PRE-Sales Selection Sheet  
Checklist

LOT 190D-25 Model: 20-1790 A The Dunmore

Sales Selection Sheet

Wallaceton  
SCHEDULE -E

Sketch #1 THE DUNMORE

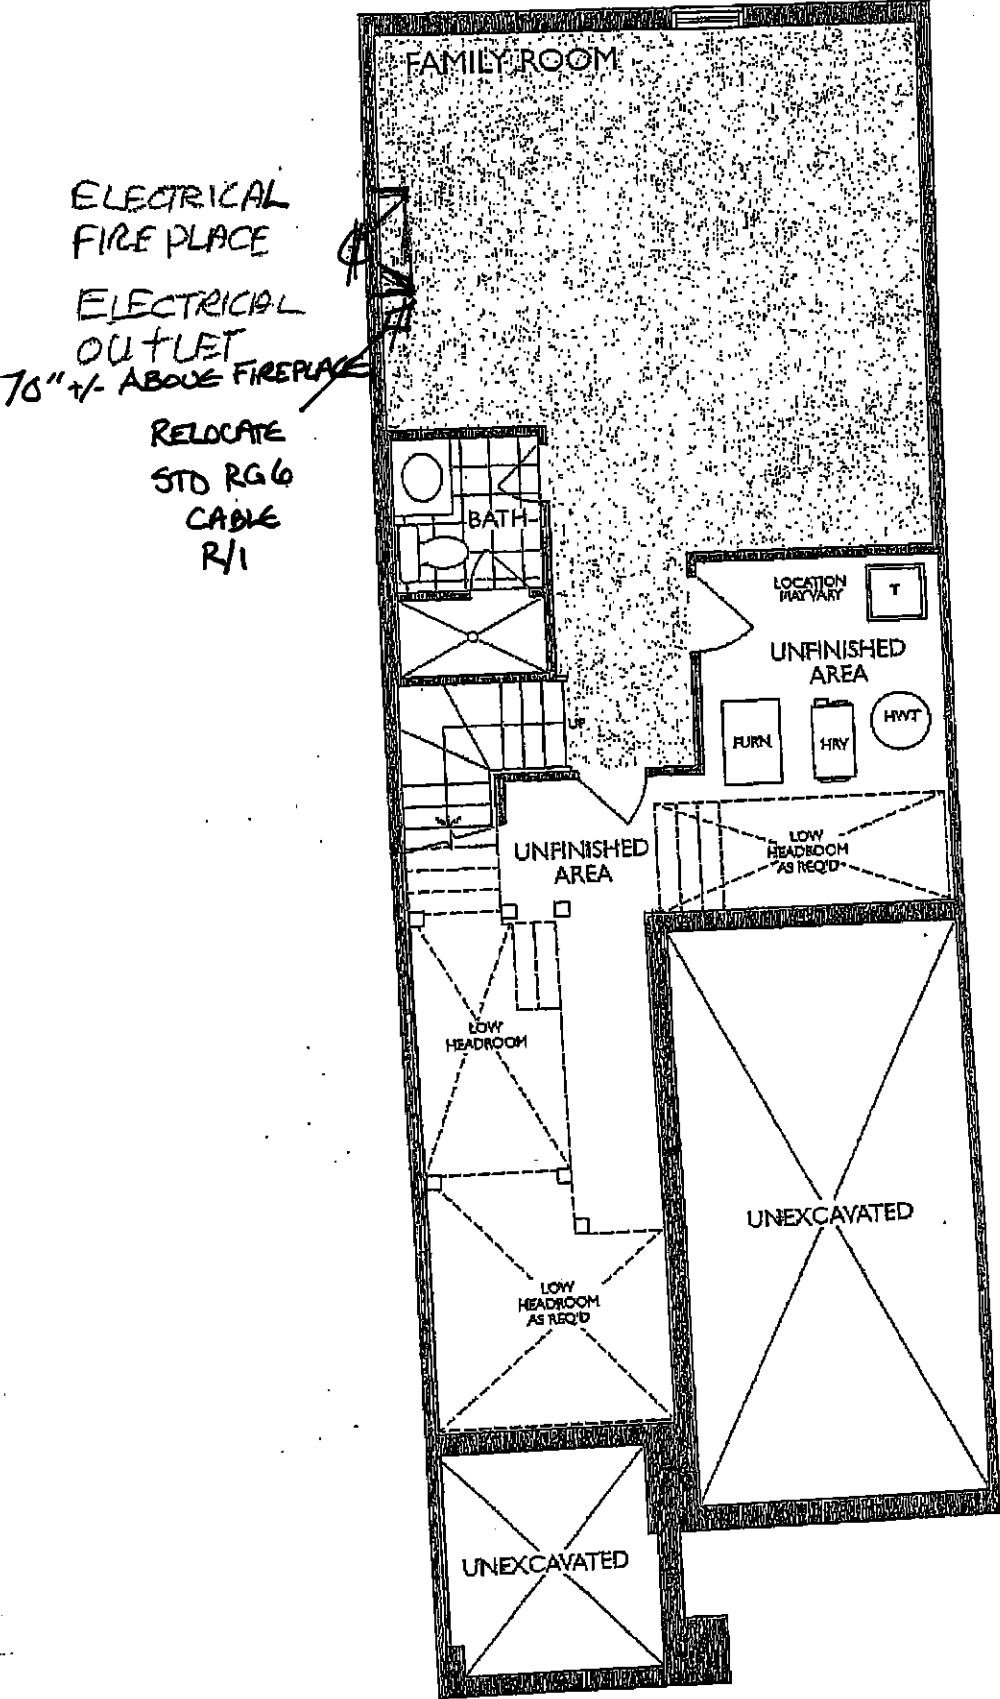
9	RELOCATE STD DUPLEX ELECTRIC FIRE PLACE INTO THE BASEMENT FAMILY ROOM SEE SKETCH # 1 PAGE 5	Qty: 1
30,473	Note:

*11 189,775  30,476	STRUCTURED WIRING - RELOCATION OF TV CABLE  <b>Note:</b> BASEMENT FAMILY ROOM, BESIDE THE FIRE PLACE SEE SKETCH # 1 PAGE 5	Qty: 1
------------------------------	---	--------

Sketch #2

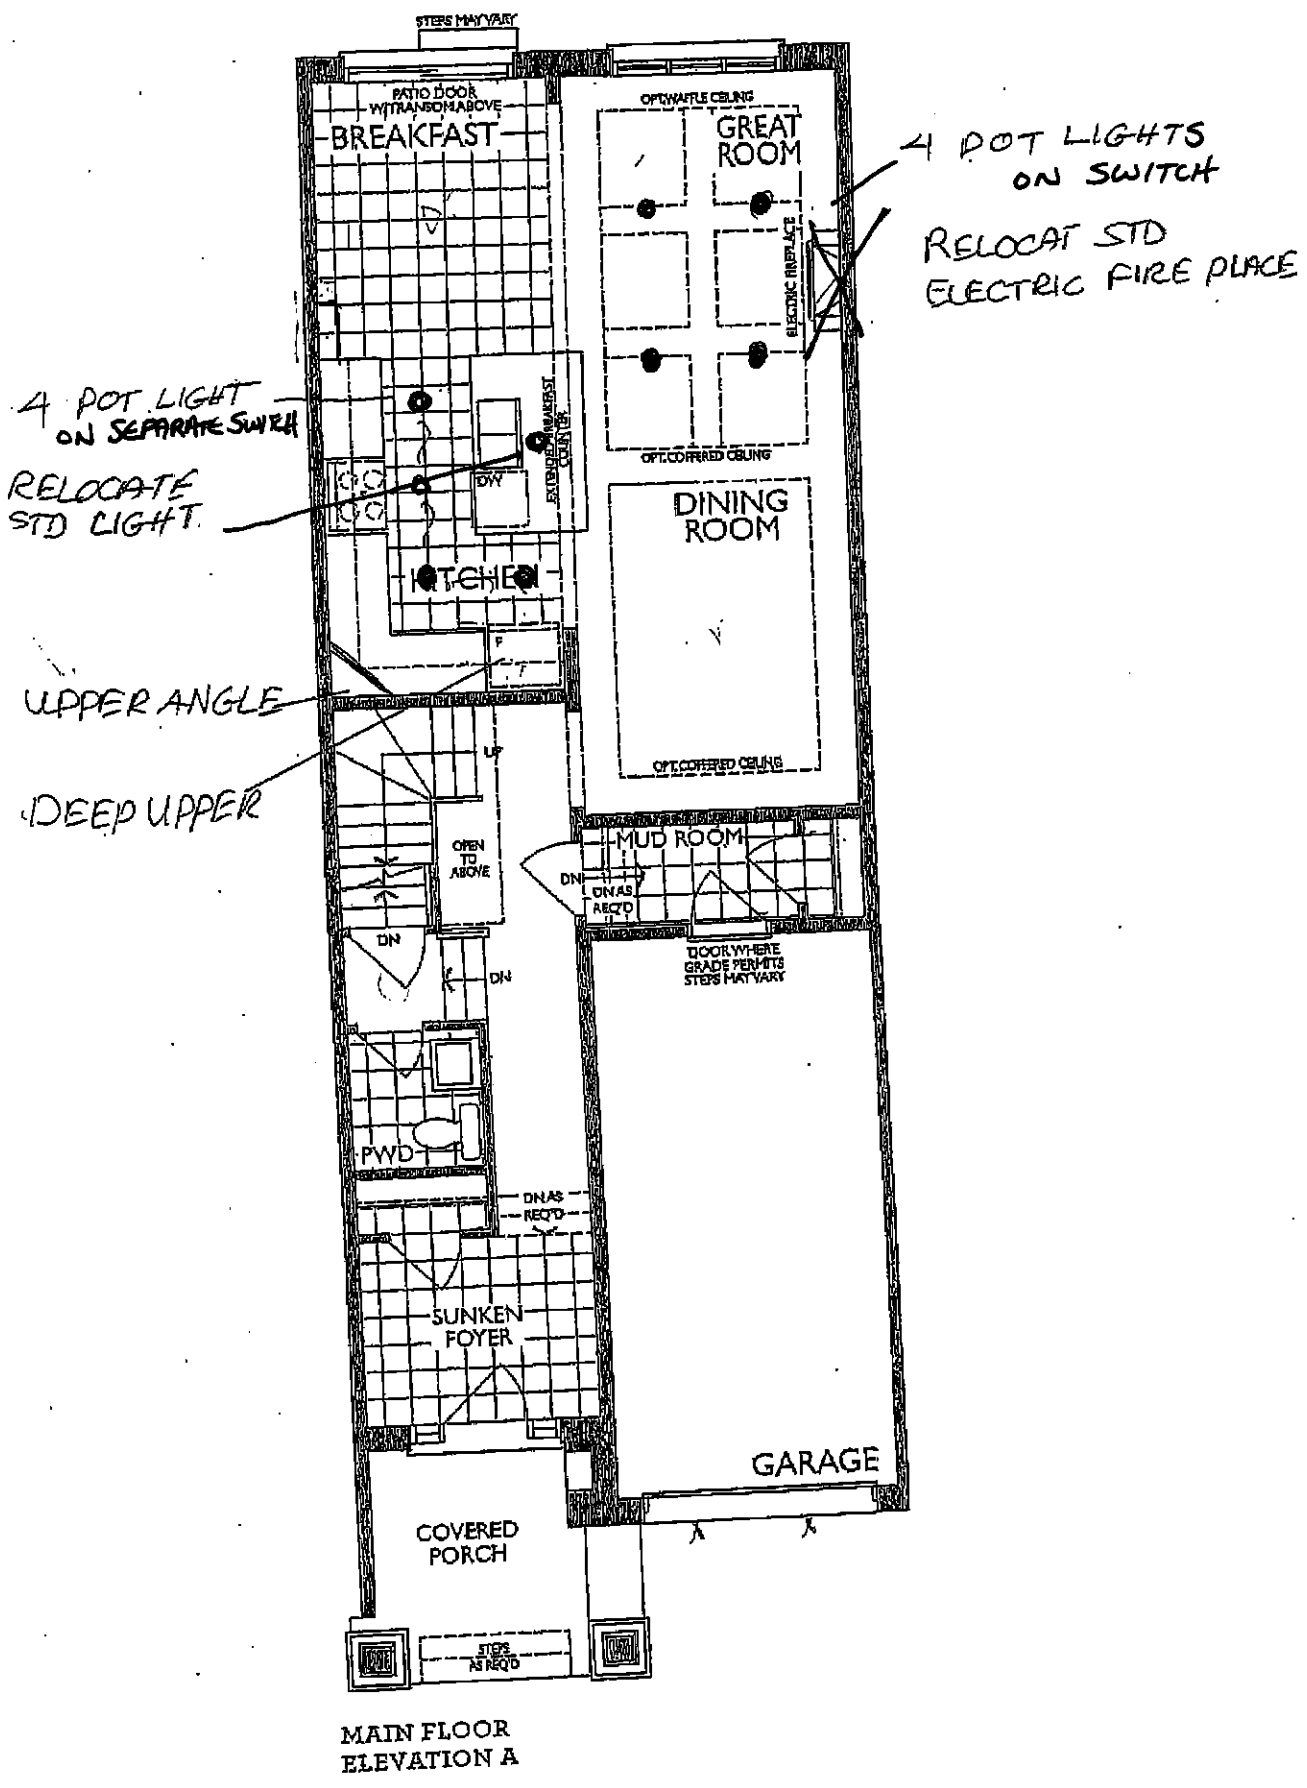
2	CABINETRY - OPT LIGHT VALANCE - KITCHEN	Qty: 1
177,094		
30,469	Note:	
*3	CABINETRY - 11A-UPPER ANGLE CORNER PER UNIT - UPGRADE 1 SKETCH # 2 PAGE 6	Qty: 1
189,343		
30,478	Note:	
4	CABINETRY - 04H-66CM DEEP FRIDGE ENCLOSURE (COUNTER DEPTH) WITH (1) WALL ([1] 66CM DEEP GABLE AND [1] 66CM DEEP CABINET) (THIS IS NOT A ZERO CLEARANCE ENCLOSURE. STANDARD HEIGHTS AND WIDTHS WILL BE USED.); PRICE ALL THE SAME FOR ALL LINES - KITCHEN	Qty: 1
189,308		
30,481	Note: SKETCH # 2 PAGE 6

*6	ELECTRICAL - POTLIGHT BUNDLE - 8 X T477GR-W 4 INCH LINE VOLTAGE POTLIGHTS INCLUDES 2 SWITCHES MAIN FLOOR (SEE SLIM LINE FOR BASEMENT) SKETCH # 2 PAGE 6	Qty: 1
189,445		
30,468	Note: 4 TO BE INSTALLED IN THE GREAT ROOM- USE SEPARATE SWITCH 4 TO BE INSTALLED IN THE KITCHEN -USE SEPARATE SWITCH	
*7	ELECTRICAL - RELOCATION OF LIGHTS (MUST SPECIFY LOCATION) - NOTE: PLUGS CANNOT BE RELOCATED- MUST PURCHASE ADDITIONAL OUTLET. SKETCH # 2 PAGE 6	Qty: 1
189,417		
30,474	Note: RELOCATE STD. KITCHEN LIGHT TO BE CENTERED OVER THE ISLAND - USE SEPARATE STD KITCHEN SWITCH	
*8	ELECTRICAL - EXTRA WALL INTERIOR OUTLET ON EXISTING CIRCUIT (DOES NOT INCLUDE KITCHEN OUTLETS) SKETCH # 1 PAGE 5	Qty: 1
189,448		
30,475	Note: BASEMENT FAMILY ROOM: TO BE INSTALLED 70" ABOVE THE CENTRE OF THE FIRE PLACE

Sketch #3

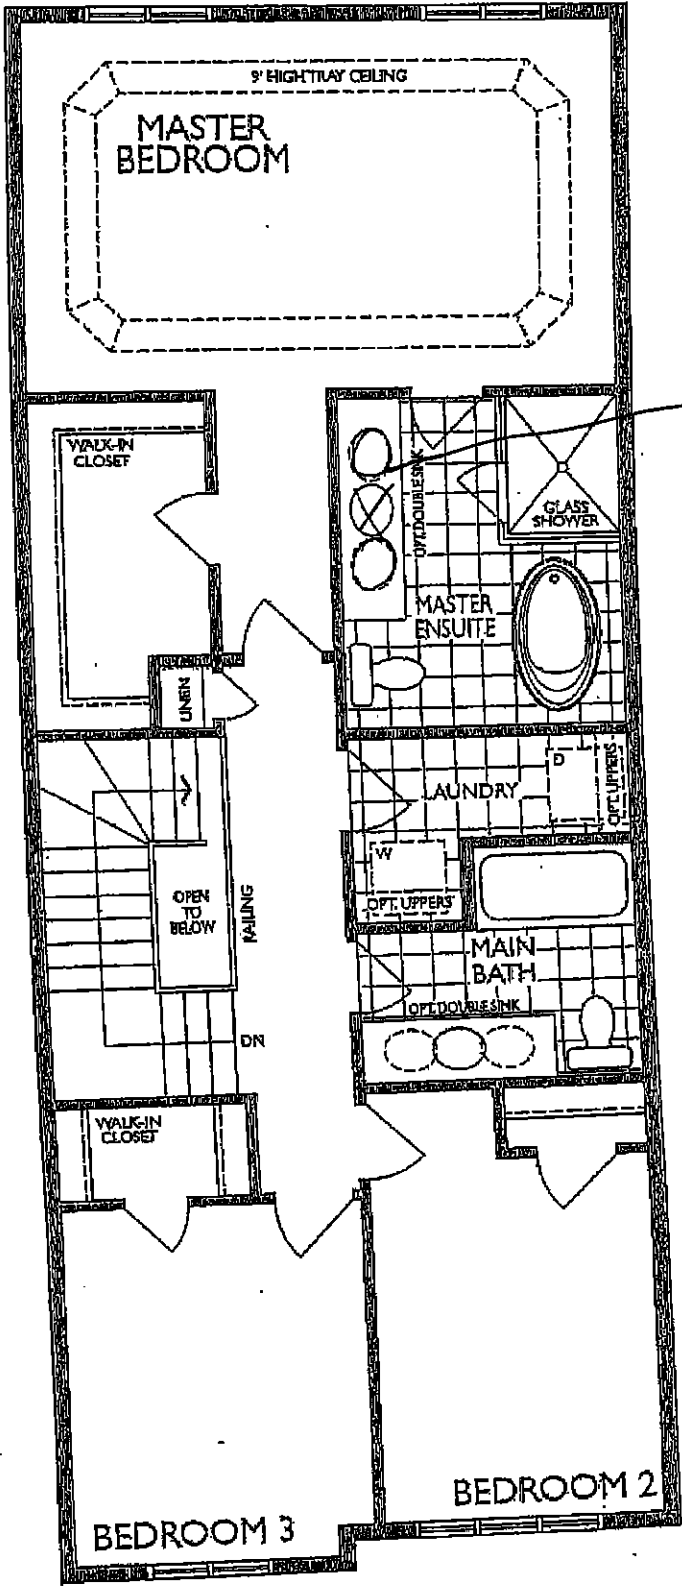
*10 189,689  30,480	PLUMBING - OPTION FROM ONE SINK TO DOUBLE SINKS INCLUDING STD CHATEAU FAUCET, STD COLONY SINK, INCLUDING CABINET CONVERSION 2D VIKING AND ONE EXTRA VANITY LIGHT SKETCH # 3 PAGE 7  <b>Note:</b>	Qty: 1
------------------------------	--	--------

OPTIONAL  
DOUBLE SINKS
